Idea: Construct a new ramp and acceleration lane from southbound Shaganappi Trail to eastbound 16 Avenue

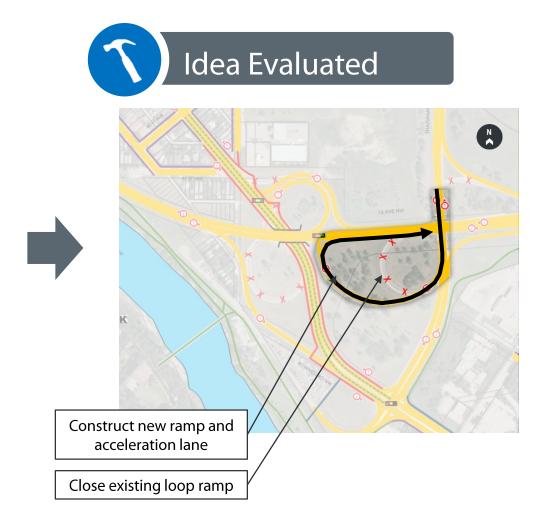
- Would a speed limit reduction and better signage reduce collisions?
- Concern that idea requires a lot of space and the removal of a significant number of trees.

- This addresses the most significant collision history issue within the study area.
- Trees would need to be removed for construction (Future study to review and minimize impacts).

Idea: New traffic signal to control northbound Bowness Road to

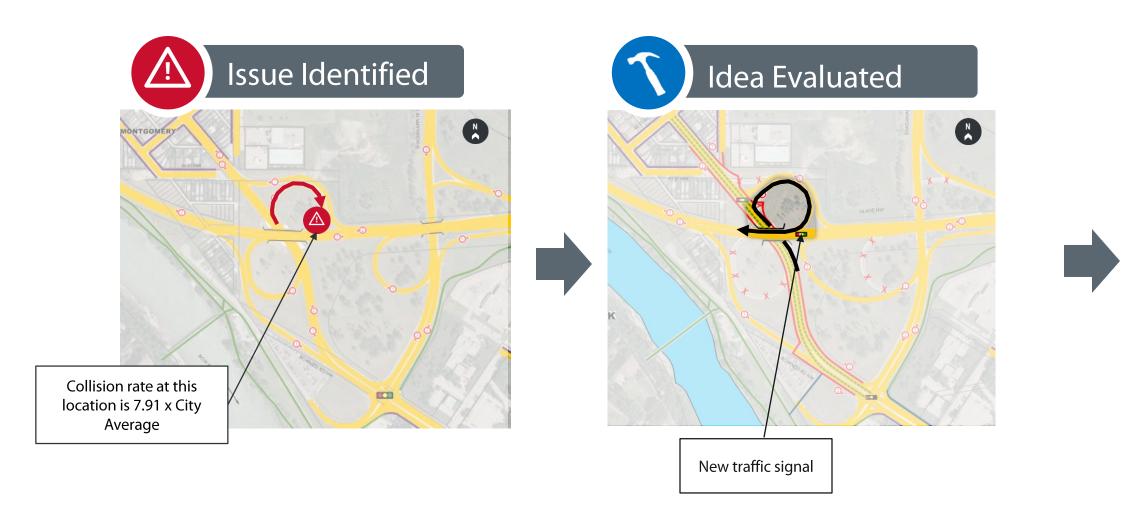
- Concern that the traffic signal will create congestion.
- Consider placing dual lanes on the loop ramp.

- Idea would minimize collisions at this location.
- A dual lane entrance ramp is feasible, and will improve the operation of this intersection beyond the operation offered by a single lane signalization.
- A two phase signal would control the westbound movement on 16 Avenue and the on-ramp movement from Bowness Road. The eastbound movement on 16 Avenue would remain free flowing.

Idea: Introduce left turn from southbound Shaganappi Trail to westbound 16 Avenue

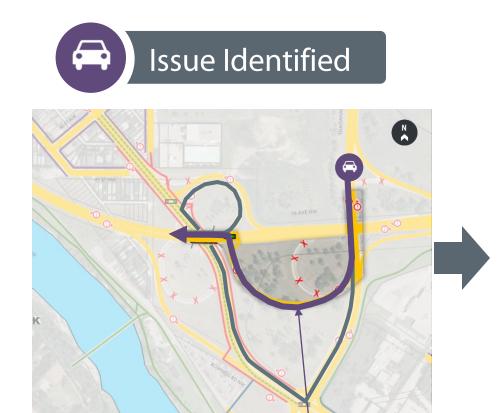
• Concerns with increased traffic delays and shortcutting through Montgomery.

• Impacts to operations of all movements at this intersection.

Idea: Close the existing loop ramp from southbound Bowness Road to eastbound 16 Avenue

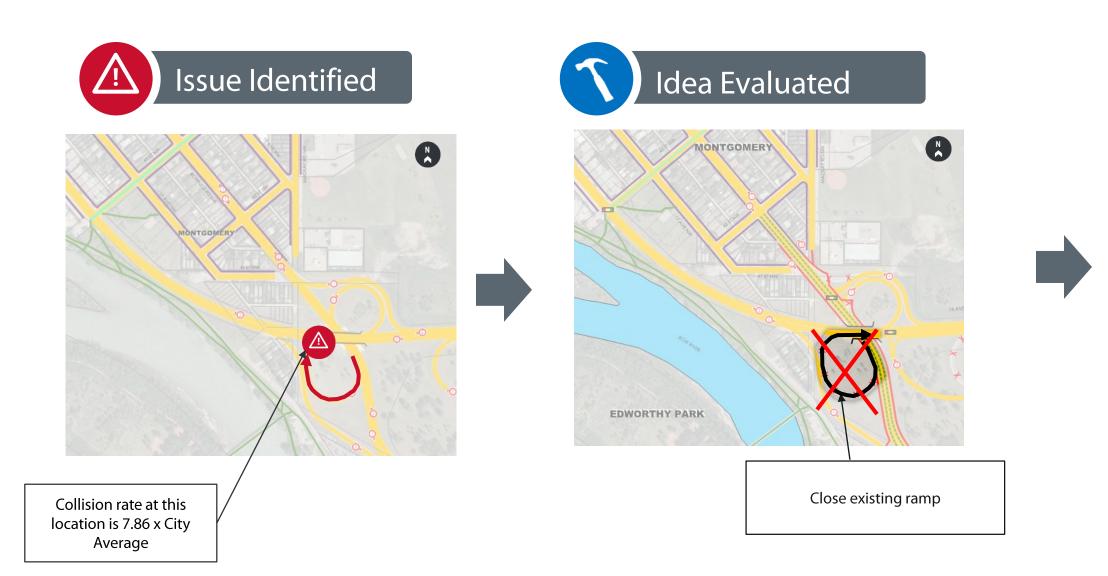
• Concerns that it will impact the operation of Shaganappi Trail and Bowness Road NW.

- Based on the detailed safety assessment completed, the benefit to cost ratio of this change is more moderate when considering both the increased collisions elsewhere and cost for construction.
- With no rerouting of traffic on 43 Street NW, there are impacts to the operation of Bowness Road and Shaganappi Trail (with and without the implementation of dual eastbound left turn lanes).

Idea: New traffic signal at 43 Street and 16 Avenue to provide additional capacity for people who drive

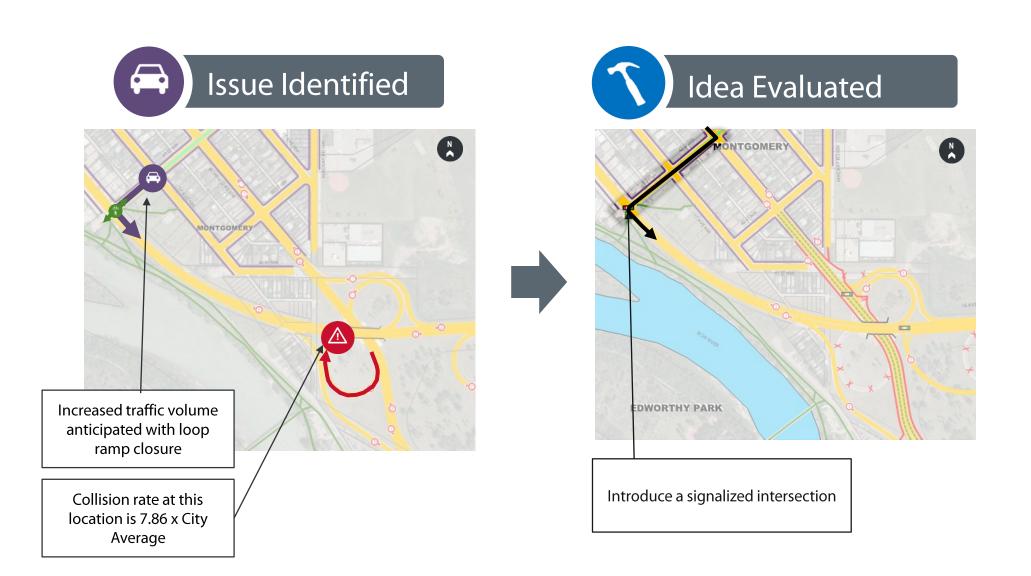
- Strong opposition due to the additional traffic it may create on a residential street.
- Would be supportive of a traffic control signal for people who walk, and/or to end 43 Street as a cul de sac.

- Additional traffic on 43 Street will introduce new safety concerns at 16 Avenue and along 43 Street.
- Impacts to traffic operation on 16 Avenue.

Idea: Close existing connection from westbound 16 Avenue to southbound Shaganappi Trail and replace with a new traffic signal at Bowness Road and the 16 Avenue off ramp.

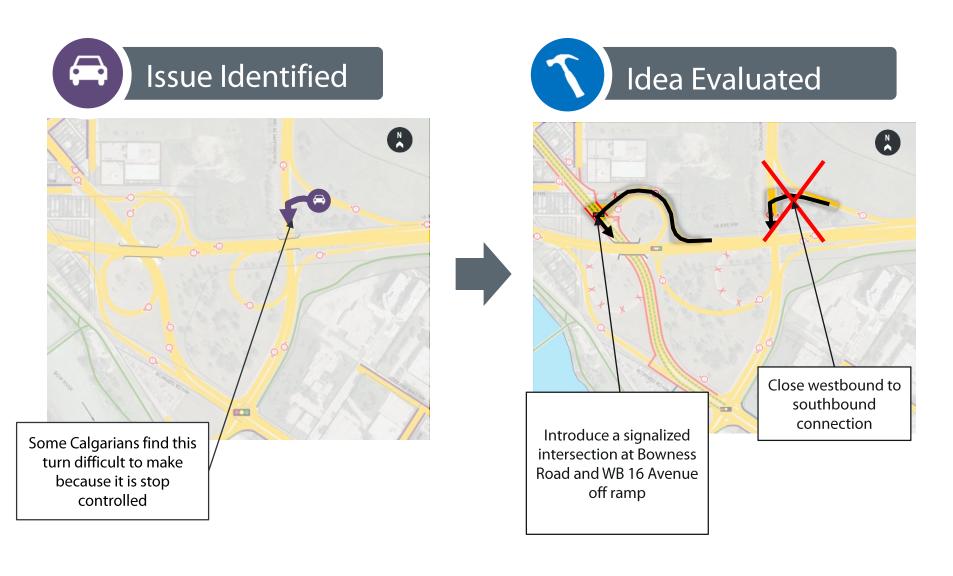
Addressing this issue would be costly and has limited benefits, as people who drive are able to access westbound 16 Avenue from 29 Street.

- Does not address an existing collision history issue
- Alternative access provided at 29 Street

Idea: Introduce connectivity enhancements along Bowness Road for people who walk and bicycle

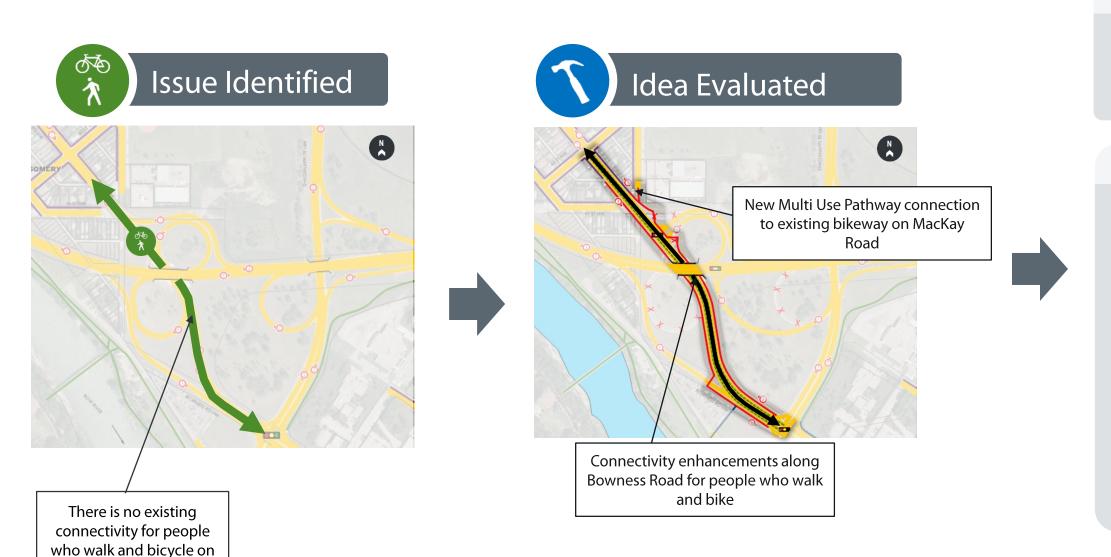
• Better connections for people who walk and bike and better access to key destinations is valued.

- Marked bicycle lanes and/or separated bicycle lanes are not feasible to introduce under the 16 Avenue Bridge on Bowness Road.
- Identification that the north side curb of Bowness Road requires replacement.
- Assessment of motor vehicle travel lane requirements through the interchange and up to 43 Street.
- Review of desire lines for people who walk and bike in this area.

Idea: Reduce the speed limit on 16 Avenue within the study area

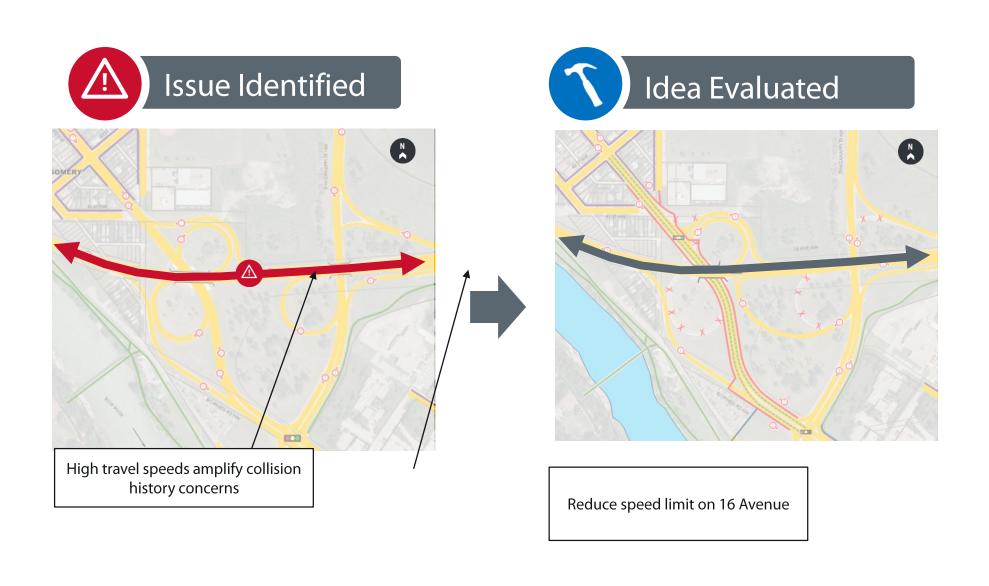
- A reduced speed limit on 16 Avenue will help address collision history issues.
- Reduced travel speeds entering into Montgomery are desired.

- A speed limit reduction by itself is not sufficient to eliminate collision history concerns.
- A broader review outside the study area is necessary to confirm the feasibility of speed limit changes.

Idea: Realign the ramp from eastbound 16 Avenue to southbound Bowness Road

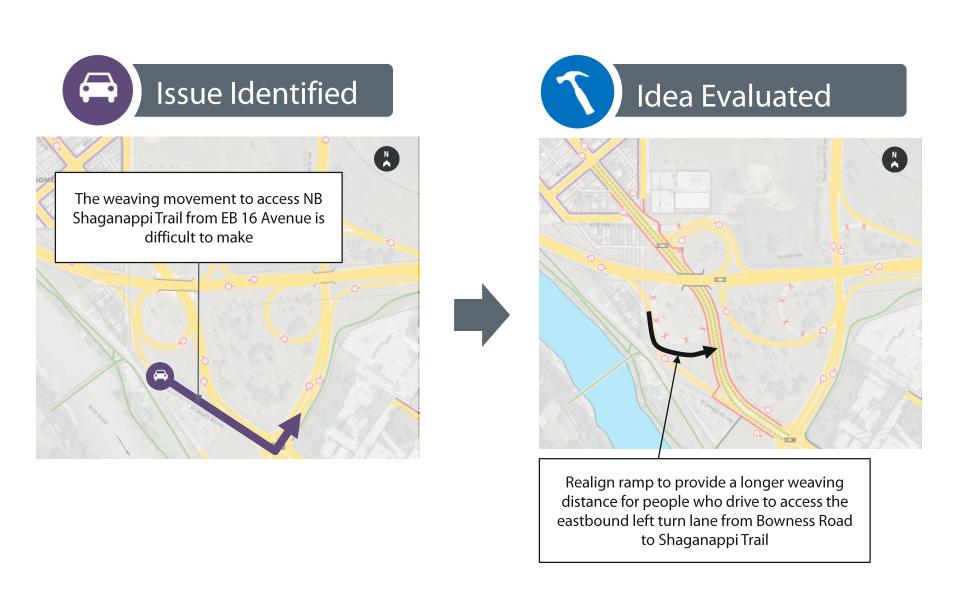
- Accessing NB Shaganappi Trail is difficult from EB 16 Avenue due to the short weaving distance from the ramp.
- This encourages more people to take Home Road instead of Shaganappi Trail

- Feasibility assessment for realignment of ramp.
- Traffic analysis for reduced ramp entry speed onto Bowness Road.
- Assessment of impacts to Bus Only Lane.

Idea: Introduce connectivity enhancements along 43 Street for people who walk and bicycle

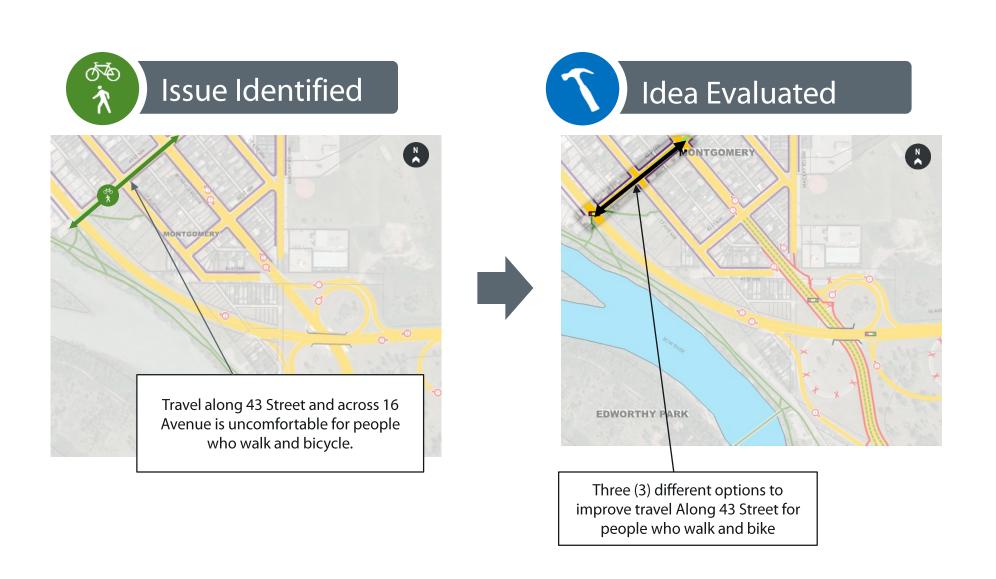
- An improved connection along 43 Street is needed to enhance comfort for people who walk and bike.
- A pedestrian overpass is desired at this location.
- 43 Street is an important link between the river and Bowness Road.
- Consider an option similar to that at 7 Street and Memorial Drive NW.

- Review feasibility of different options discussed.
- Identification of impacts to other modes of transportation for each option.

Idea: Introduce a dual left turn lane from eastbound Bowness Road to northbound Shaganappi Trail

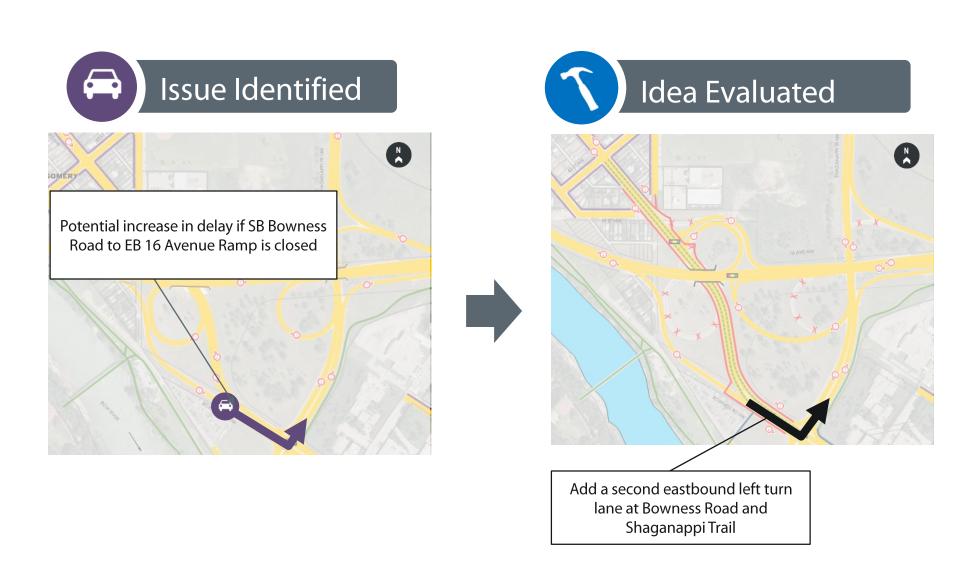
A second eastbound left turn lane at Bowness Road and Shaganappi Trail should be considered, especially if the SB Bowness Road to EB 16 Avenue ramp is being closed.

- Traffic analysis of introducing a second left turn lane (with and without closure of SB Bowness Road to EB 16 Avenue ramp).
- Feasibility assessment of the work required indicated a high cost and the potential need to acquire property because it will be necessary to widen Bowness Road between Shaganappi Trail and Point McKay Drive.

Idea: Close the south leg of the intersection and provide parking lot/residential access elsewhere

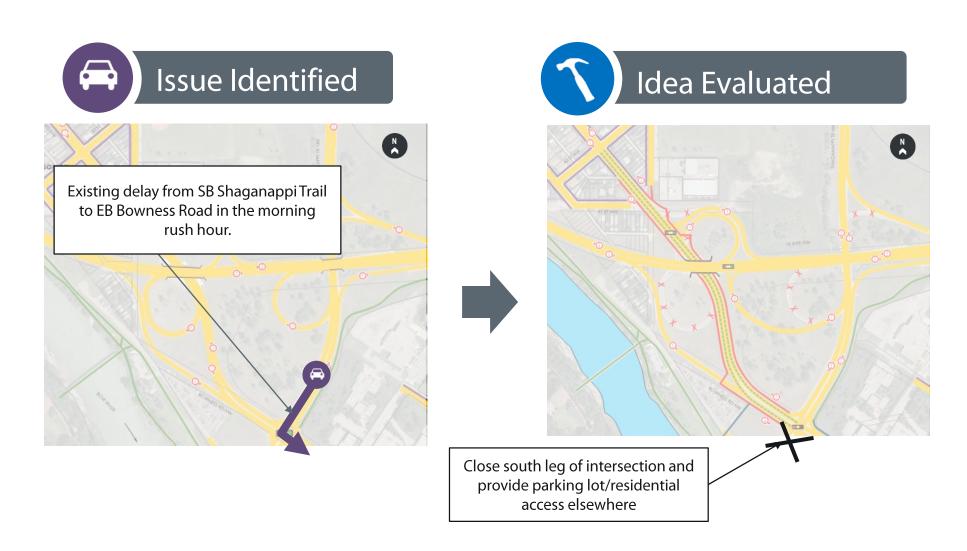
Closing the south leg of this intersection could potentially improve traffic flow during peak times.

- Traffic analysis indicated that this change does not result in improvement to traffic flow unless the east side crosswalk is closed. This is an important connection for access to the Foothills Medical Centre, and is not recommended for closure.
- Rerouting access to Point McKay Towers and the Edworthy Park parking lot would introduce additional delays elsewhere.

Idea: Introduce a new signal at 16 Avenue and 46 Street

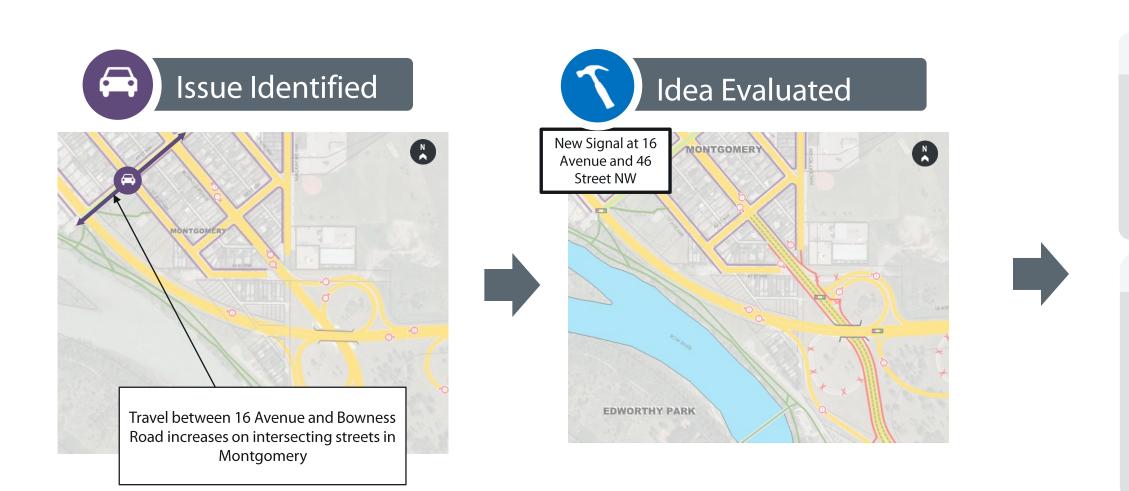
- 46 Street was identified as an area of opportunity for redevelopment through the Main Streets Project.
- Additional traffic on 46 Street may be more acceptable.

- A detailed review of this intersection was not completed, as a broader understanding of other potential changes on 16 Avenue is necessary.
- Assessment of short and long-term options as part of 16 Avenue Corridor Study recommended.

Idea: Investigate enhancements to traffic signal operations east of Shaganappi Trail on Bowness Road

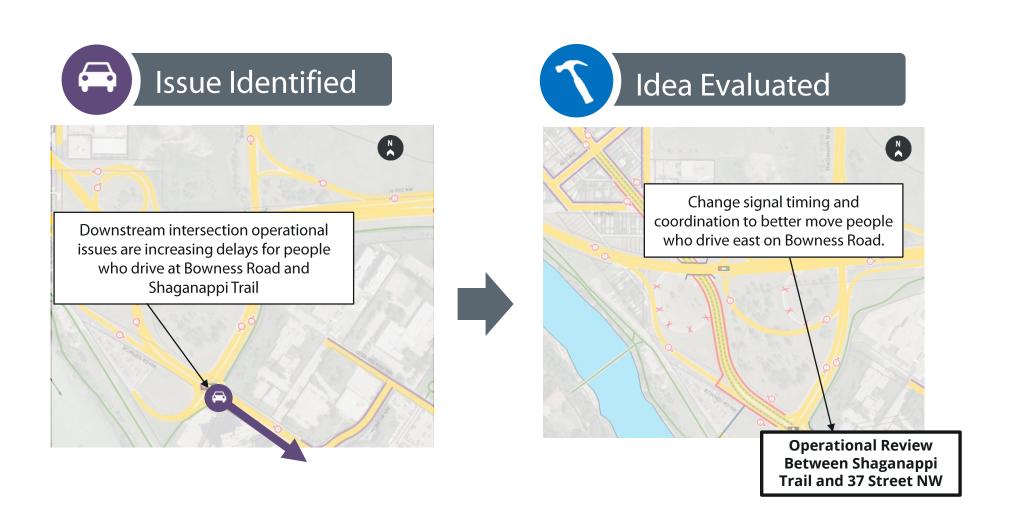
The intersection of Bowness Road and Shaganappi Trail seems to operate poorly during the morning rush hour because the signals are not well coordinated further to the east.

- Confirmation that signals are already optimized with signal cycle lengths and coordination during the rush hour periods.
- Identification that eastbound left turns are creating significant delays at 37 Street during the morning rush hour.
- Confirmation that an eastbound left turn bay will improve traffic flow.
- Planned for construction in 2017.
